Office Action Summary	Application No. 10/708,517	Applicant(s) JOHNSON ET AL.	
	Examiner Aaron M. Dunwoody	Art Unit 3679

DETAILED ACTION***Claim Rejections - 35 USC § 103***

Claims 1-3, 11, 12, 16, 18, 22, 97 and 99-103 are rejected under 35 U.S.C.

103(a) as being unpatentable over US patent 5862866, Springer in view of US patent 4865359, Roberts.

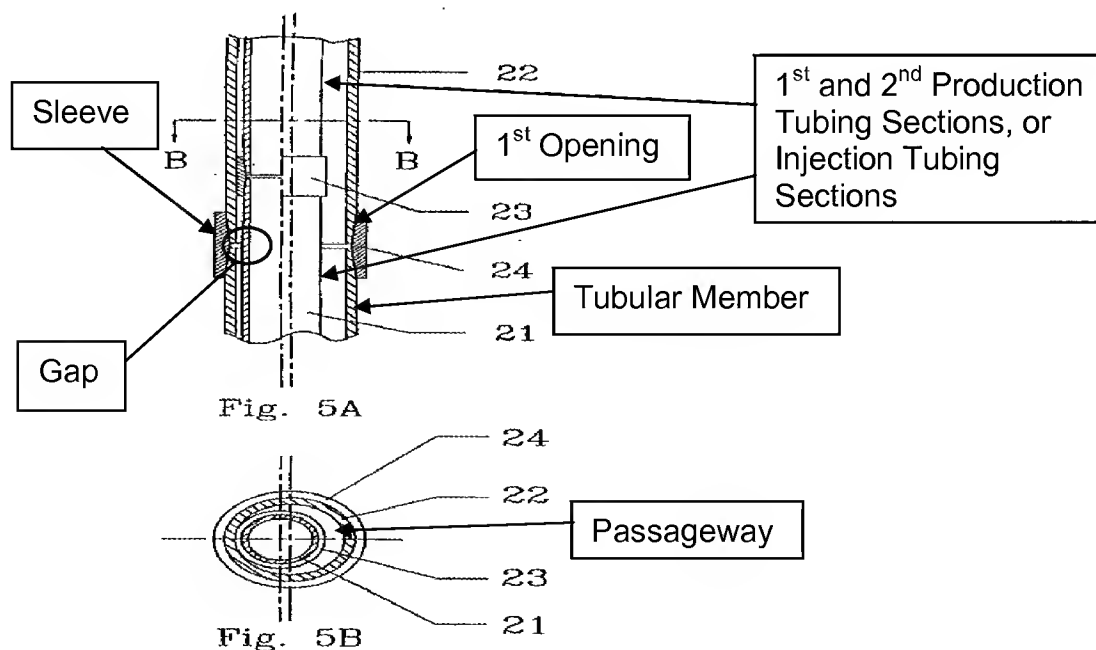
In regards to claim 1, in Figures 5A-B below, Springer discloses an apparatus usable with a well to connect a first tubing section and a second tubing section together, the apparatus comprising:

a body (22) comprising a surface; a first opening concentric with an axis to receive the first tubing section; a second opening concentric (not shown but implied) with the axis to receive the second tubing section; and a passageway eccentric with respect to the axis to communicate fluid after the first and second tubing sections are connected together by the body; a sleeve adapted to be moved from a retracted position to an extended position, the sleeve comprising a surface; and a tubular member comprising a passageway adapted to align with the passageway of the body of the connector such that a gap exists between the passageway of the body and the passageway of the tubular member when both the first and second tubing sections are fully received in the first and second openings and the sleeve is in the retracted position, wherein the sleeve is adapted to be moved to the extended position to bridge the gap. Springer does not disclose a sealing element. Roberts teaches a sealing element (25) to contribute "to formation of a gas-tight seal, and the prevention of crevice corrosion" (col. 4, lines 3-5). As Roberts relates to the method of joining pipe segments to form a pipeline, it would have obvious to one having ordinary skill in the art at the time the invention was made to provide a sealing element to contribute to formation of a gas-tight seal, and the prevention of crevice corrosion, as taught by Roberts.

In regards to claim 97, Springer in view of Roberts disclose an connector assembly usable with a well, comprising: a first body (22) comprising: a first opening concentric with an axis to receive a first tubing section, a second opening concentric with the axis to receive a second tubing section, and a passageway eccentric with respect to the axis to communicate fluid after the first and second tubing sections are connected together by the first body; and a second body (tubular member in Figure 5a above) connected to the second tubing section and comprising another passageway

coaxial with the passageway of the first body, the second body comprising a surface; a sleeve (see Figure 5a above) mounted on the second body adapted to be moved from a retracted position to an extended position, the sleeve comprising a surface; and a sealing element to form a sealing contact with the surface of the second body and with the surface of the sleeve when the sleeve is in the extended position wherein a gap exists between the passageway of the first body and the passageway of the second body when both the first and second tubing sections are fully received in the first and second openings and the sleeve is in the retracted position, and the sleeve is adapted to move to the extended position to bridge the gap.
